UNITED STATES PATENT AND TRADEMARK OFFICE

APPLICATION NO.	FILING DATE	FIRST NAMED INVENTOR	ATTORNEY DOCKET NO.	CONFIRMATION NO.
09/934,482	08/23/2001	Naoya Motegi	ASA-1025	8422

Office Action Summary

FIG. 4

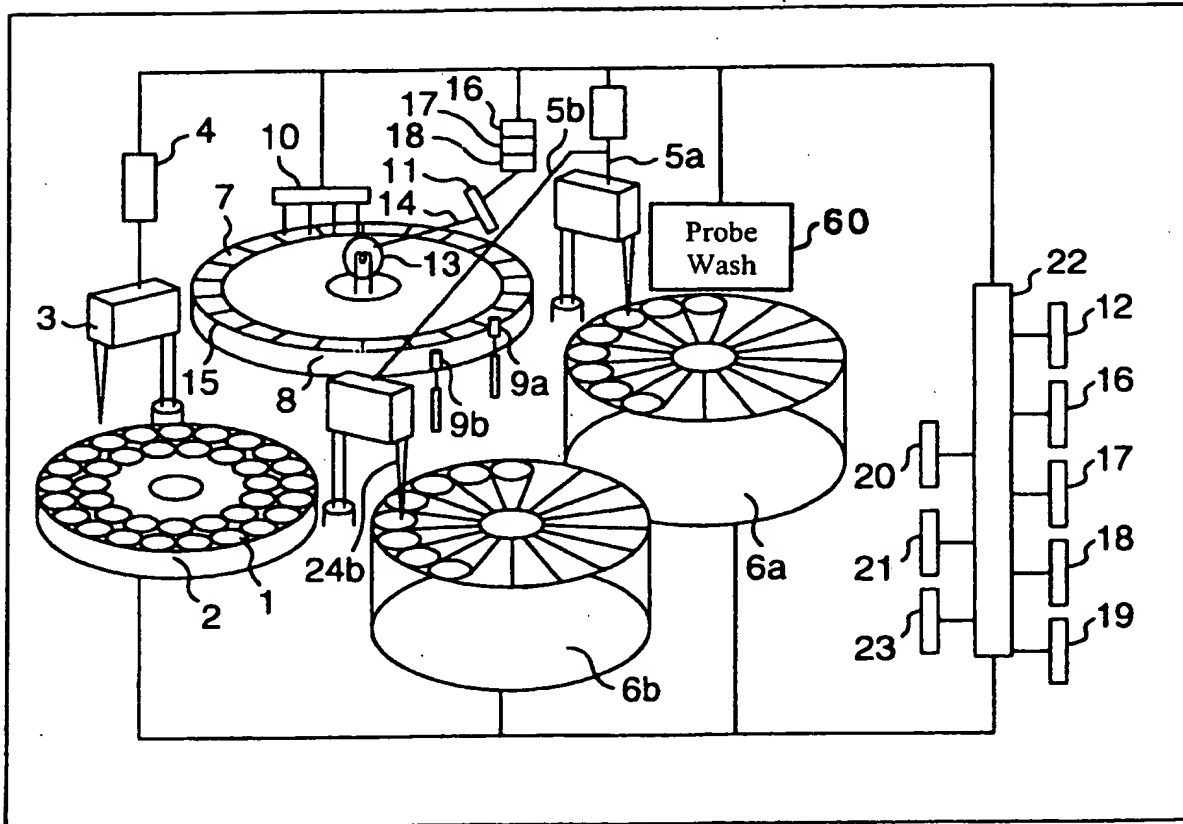
2. The drawings were received on June 30, 2005. These drawings are accepted.
3. The drawings are objected to as failing to comply with 37 CFR 1.84(p)(5) because they include the following reference character(s) not mentioned in the description: 60 in the newly submitted replacement drawing. Corrected drawing sheets in compliance with 37 CFR 1.121(d), or amendment to the specification to add the reference character(s) in the description in compliance with 37 CFR 1.121(b) are required in reply to the Office action to avoid abandonment of the application. Any amended replacement drawing sheet should include all of the figures appearing on the immediate prior version of the sheet, even if only one figure is being amended. Each drawing sheet submitted after the filing date of an application must be labeled in the top margin as either "Replacement Sheet" or "New Sheet" pursuant to 37 CFR 1.121(d). If the changes are not accepted by the examiner, the applicant will be notified and informed of any required corrective action in the next Office action. The objection to the drawings will not be held in abeyance.
